Official Transcript of Proceedings
NUCLEAR REGULATORY COMMISSION

Title: Advisory Committee on Reactor Safeguards
 Materials, Metallurgy, and Reactor Fuels

Date: Wednesday, May 6, 2020

TRISO Fuel Topical Report

RAI #2.1: Kernel-to-Buffer Volume Ratio

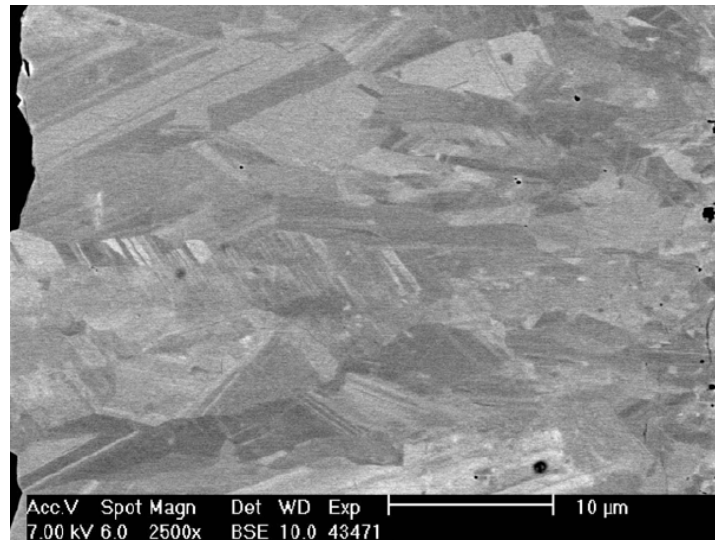
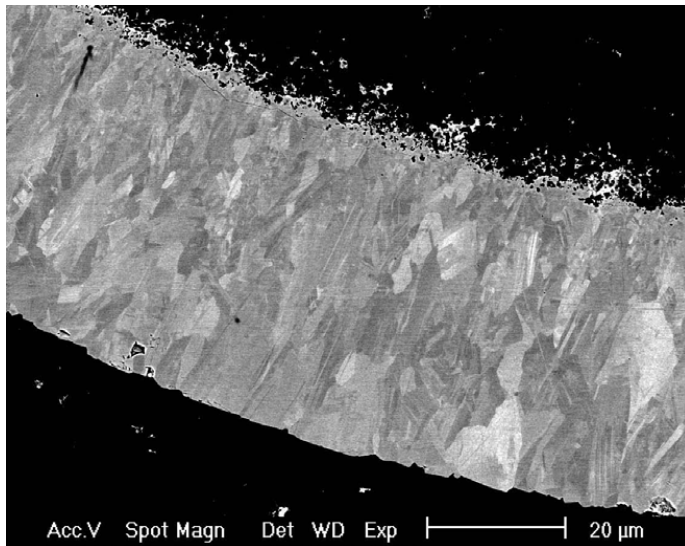
RAI: Are there important fuel properties beyond those included in Table 5-5, or key coating process parameters?

- Kernel-to-buffer volume ratio
- SiC microstructure
- UCO kernel stoichiometry
- Uninterrupted coating process

- SiC stress metric discussed in Section 4 of topical report

$$\sigma \propto \frac{B \cdot V_k}{V_b} \cdot \frac{r_{SiC}}{t_{SiC}} \quad \text{Eq. 4.1}$$

SiC Microstructure Comparison

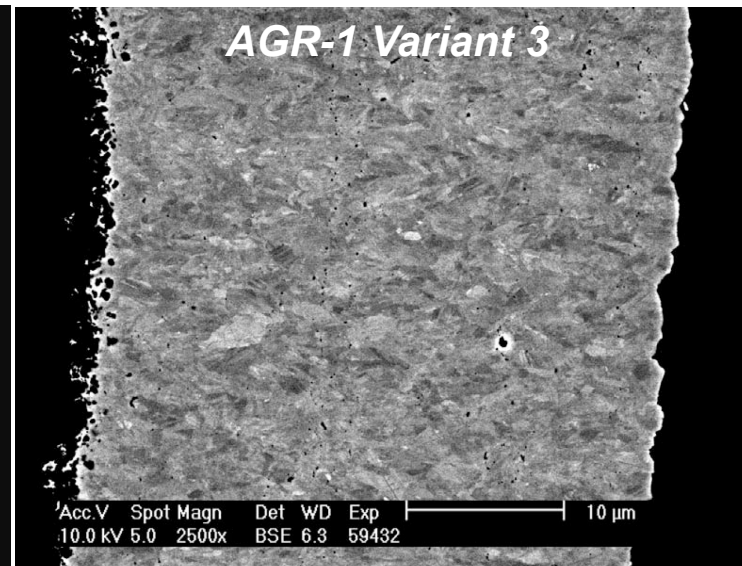
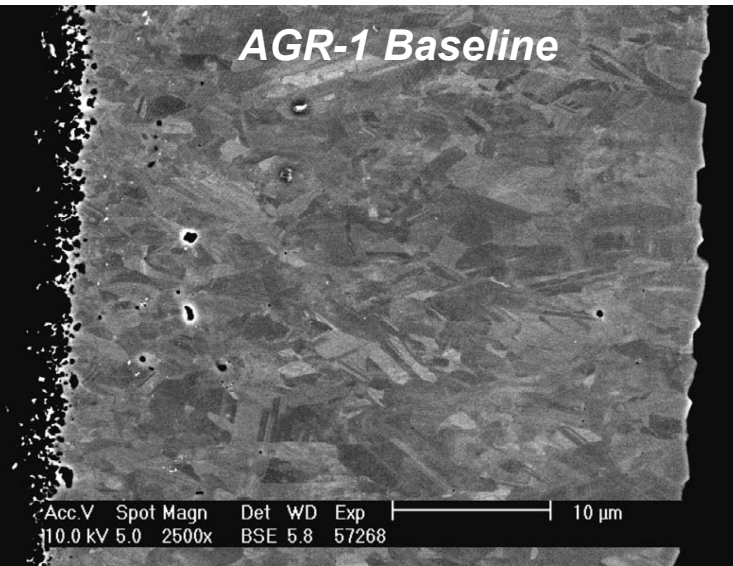
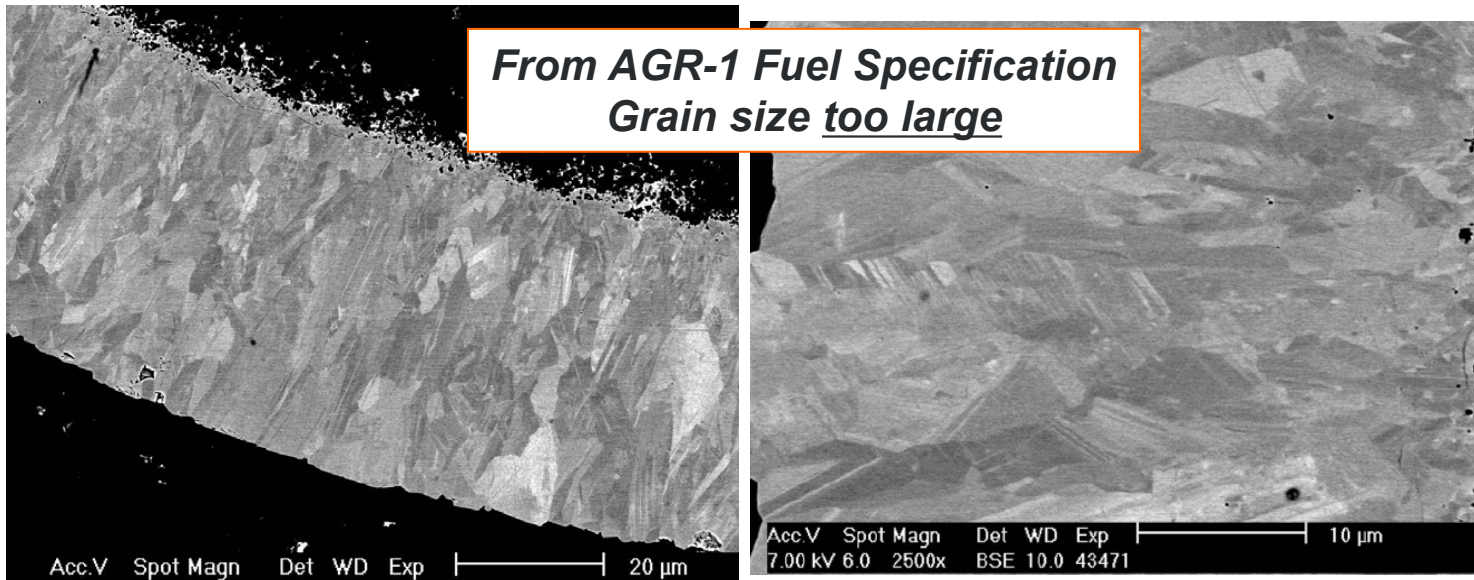
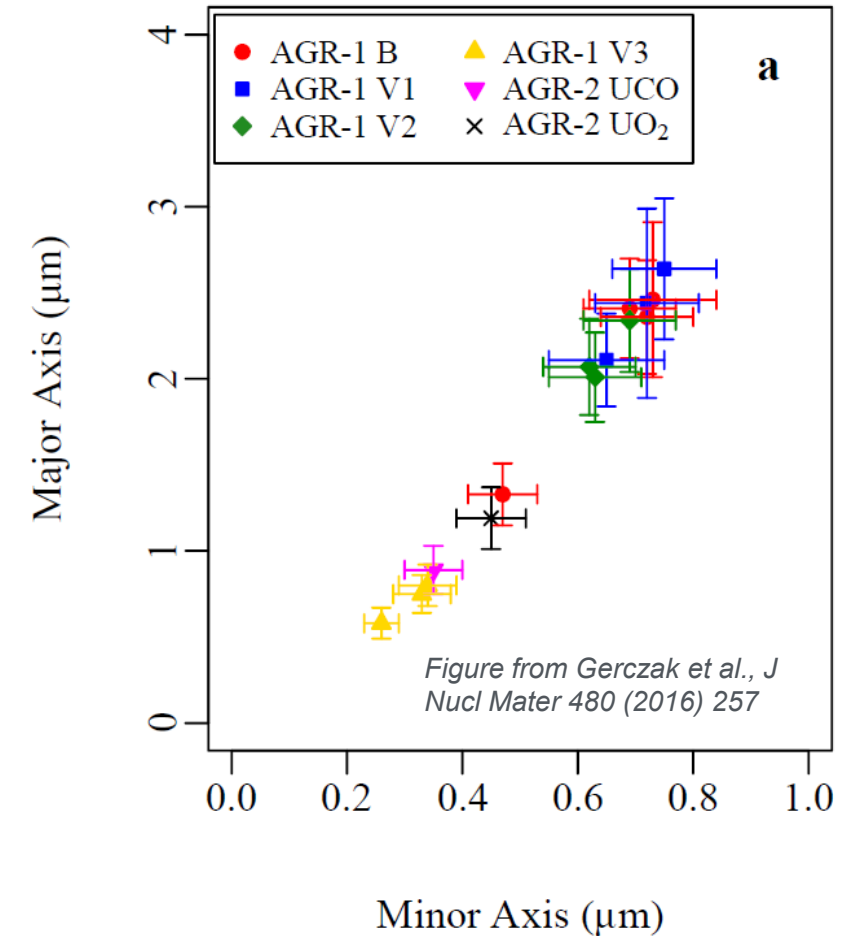
There was a question about uninterrupted coating, if that's a requirement. The fact is it is a de facto standard in modern TRISO fabrication. Most of the historic data sets that we refer to have used this process.

*From AGR-1 Fuel Specification
Grain size too large*

SiC grain size of AGR-1 and AGR-2 fuel particles
(Data presented in Table 5-3)

- No significant performance differences were noted between the different AGR-1 and AGR-2 fuel particles during irradiation or in post-irradiation heating at 1600 – 1700°C
 - No difference in fission product release
 - No difference in TRISO or SiC layer failure fractions
- Smaller-grained SiC exhibits increased fission product release (e.g., Ag, Eu, Sr) when heated at 1800°C for >100 h
- This negligible difference in performance indicates that none of the AGR SiC types were approaching a limiting value in terms of grain size
